EIS APPENDICES

BULL MOUNTAIN NATURAL GAS PIPELINE PROJECT

DEIS Formal Notice and Comment Analysis

APPENDIX Q, RESPONSE TO COMMENTS

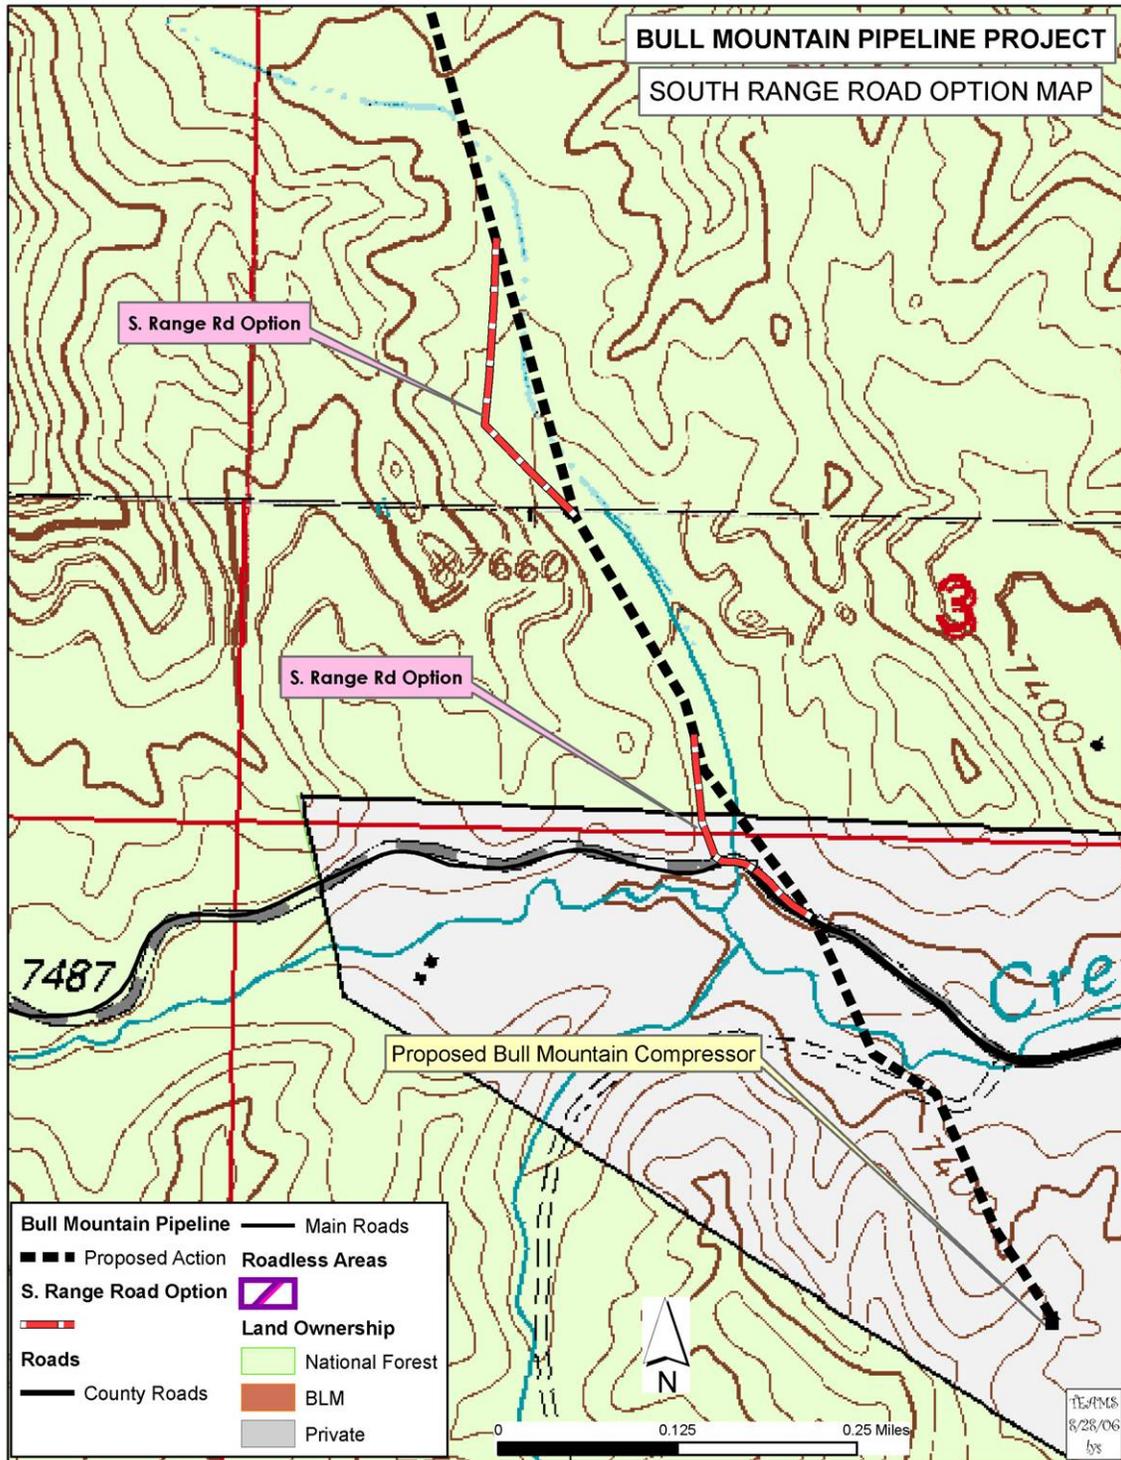
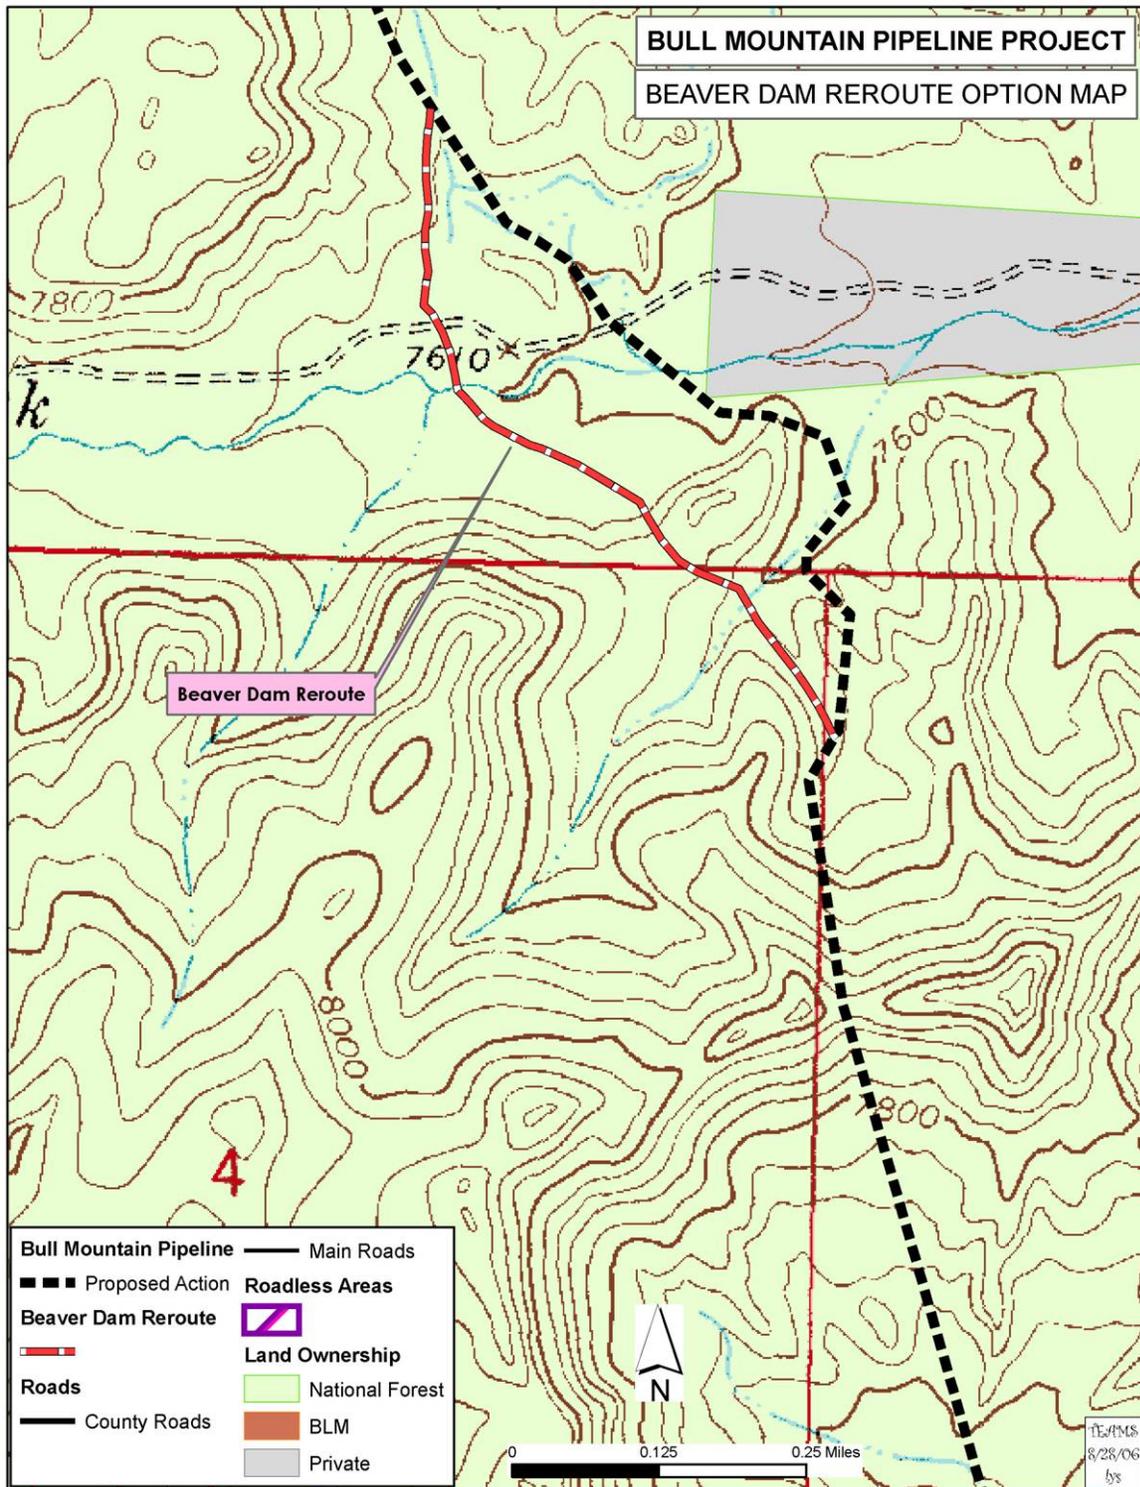
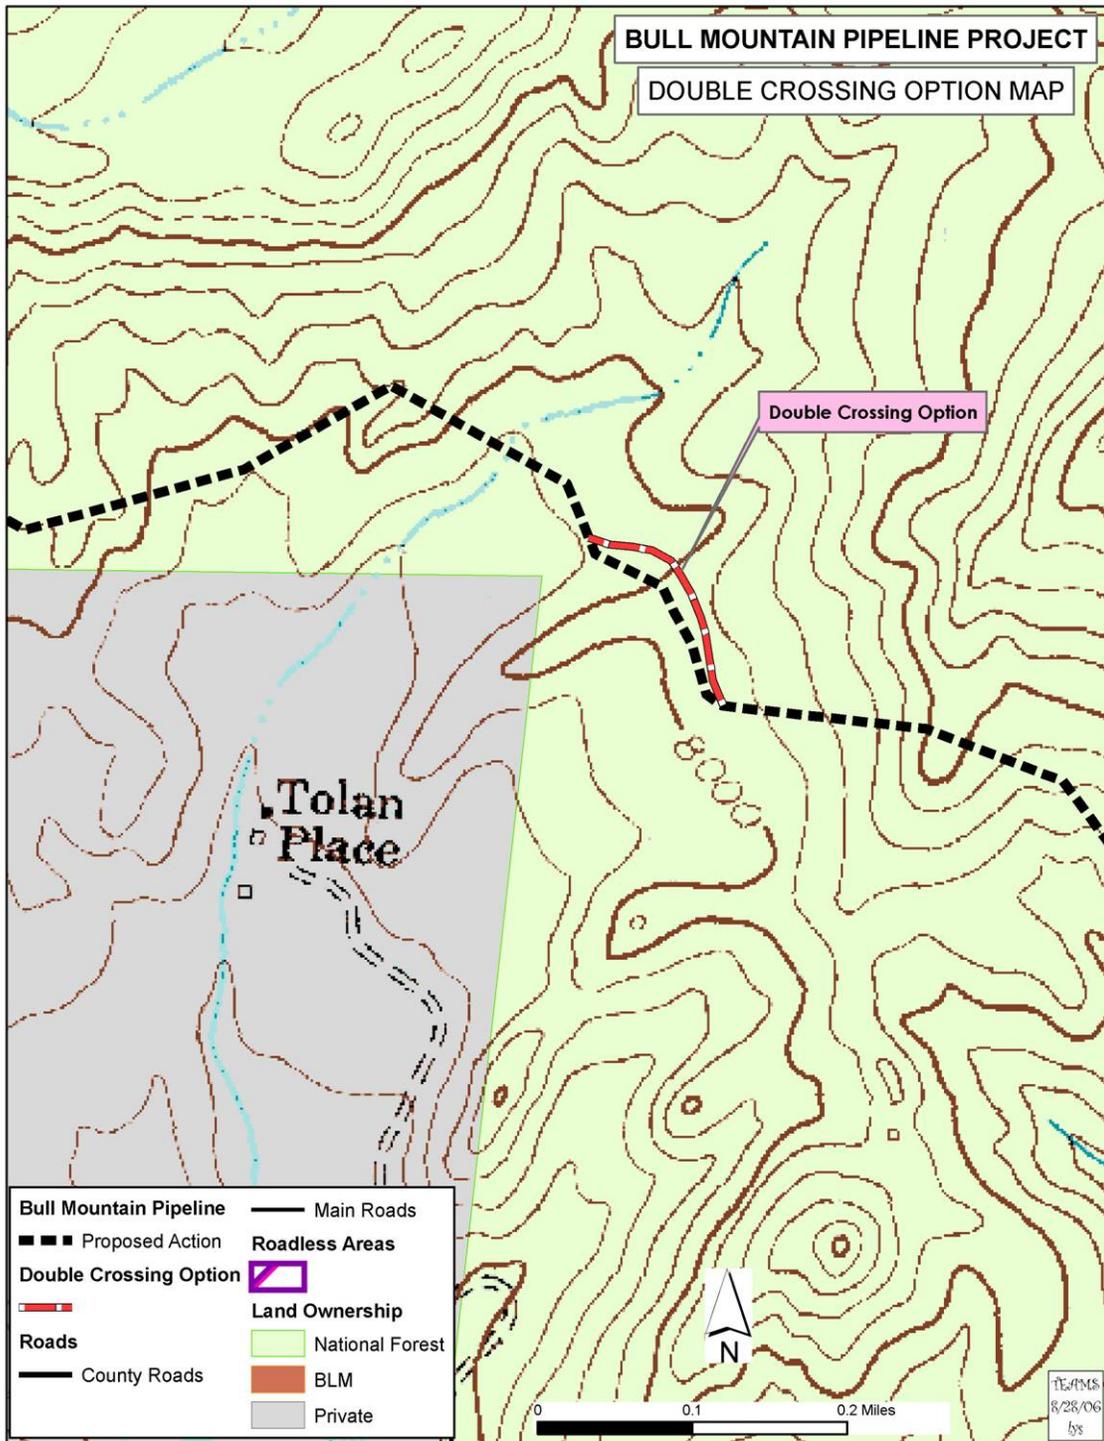
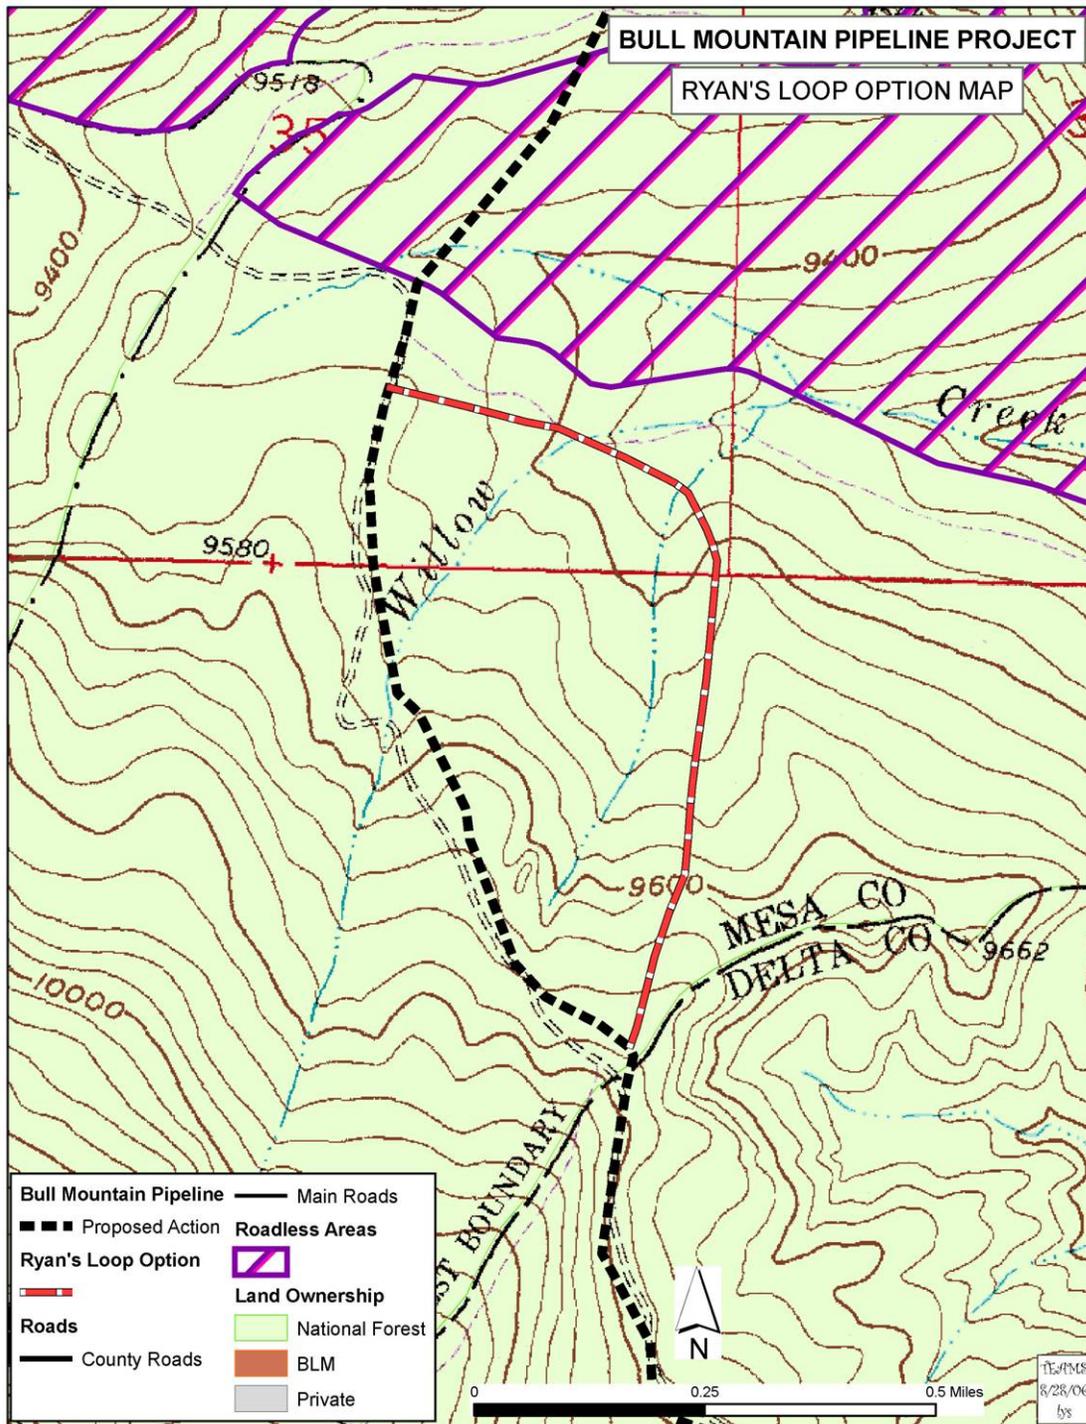
35.122 Appendix A The maps of the FS route wiggles are shown on figures 4-7 but not on figure 2, where the route wiggles are shown only on Alternative 1. SG has agreed to incorporate these route wiggles into the proposed action. Maps should indicate these reroutes to the PA for resource protection.	The FEIS will likely delete the discussion of these minor route corrections and they would just be considered to be part of the alternatives that are pertinent (PA and Alt 1).
